Service Letter No. 339

**SUBJECT:** Insulation of Wiring at Starter Solenoid Switch

**MODELS AFFECTED:** PA-24 and PA-24-250 Comanches  
Serial Numbers 24-1 to 24-1881 inclusive, 24-1883 to 24-1919 inclusive, 24-1921 to 24-1932 inclusive, 24-1934 to 24-1962 inclusive, 24-1964 to 24-1981 inclusive, 24-1983 to 24-1987 inclusive, 24-1989 to 24-2001 inclusive, 24-2003 to 24-2006 inclusive, 24-2008 to 24-2010 inclusive, 24-2012 to 24-2021 inclusive, 24-2023 to 24-2026 inclusive, 24-2028 to 24-2030 inclusive, 24-2032, 24-2033, 24-2035, 24-2037 to 24-2040 inclusive, 24-2042 to 24-2044 inclusive, 24-2046 to 24-2069 inclusive, 24-2071 to 24-2078 inclusive, 24-2080 to 24-2085 inclusive, 24-2087 to 24-2092 inclusive, 24-2094 to 24-2105 inclusive, 24-2107 to 24-2109 inclusive, 24-2113 to 24-2118 inclusive, 24-2120, 24-2122, 24-2123, 24-2125, 24-2128 to 24-2132 inclusive, 24-2134, 24-2135.

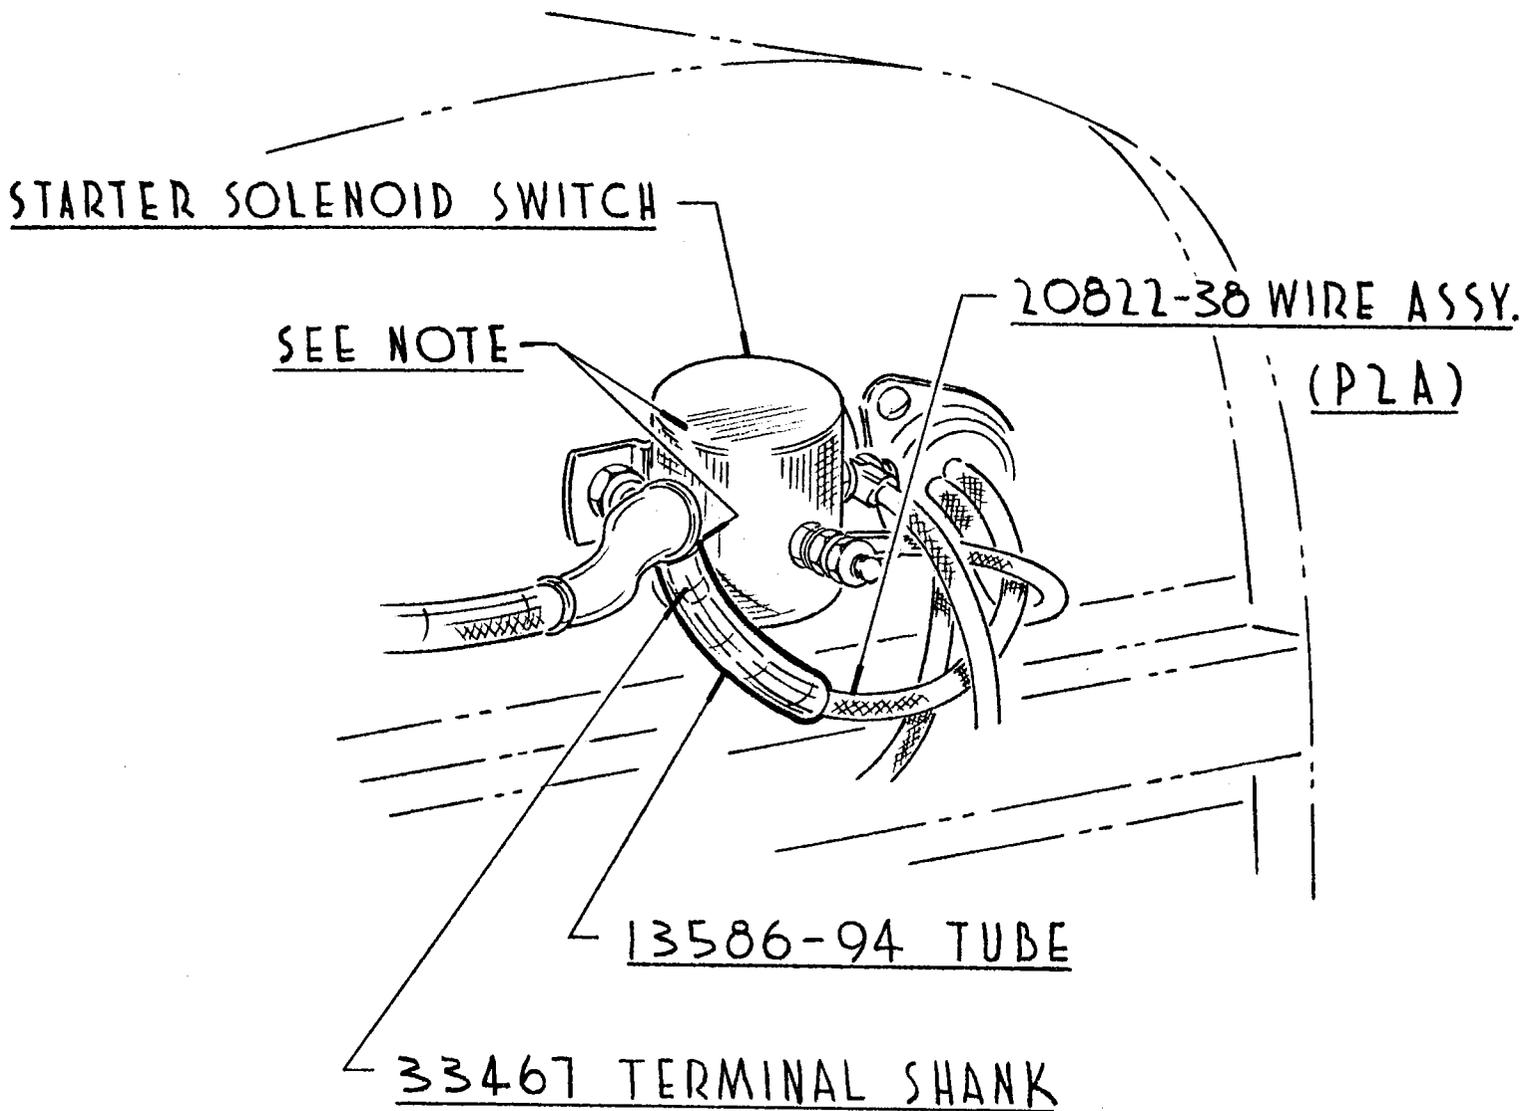
This Service Letter is to advise that a modification has been made to the wiring at the starter solenoid switch. The subject aircraft as indicated by the above serial numbers shall be modified in accordance with the following instructions and enclosed sketch.

1. A piece of plastic insulating tubing, part number 13586-94, two inches long shall be installed over part number 33467, terminal shank, on wire assembly, part number 20822-38.
2. The subject terminal, part number 33467-00, located on the right side of the starter solenoid switch on the forward side of the firewall shall be installed in such a manner as to provide maximum clearance between the terminal shank and the solenoid housing.

The wire assembly, part number 20822-38 installed on Serial Numbers 24-1 to 24-102 inclusive, is of a smaller diameter than those used on succeeding aircraft. The insulated tubing supplied would be of a slightly larger diameter. These must be secured at each end.

INSTALL TERMINAL TO PROVIDE MAX. CLEARANCE  
BETWEEN TERMINAL SHANK & SOLENOID HOUSING
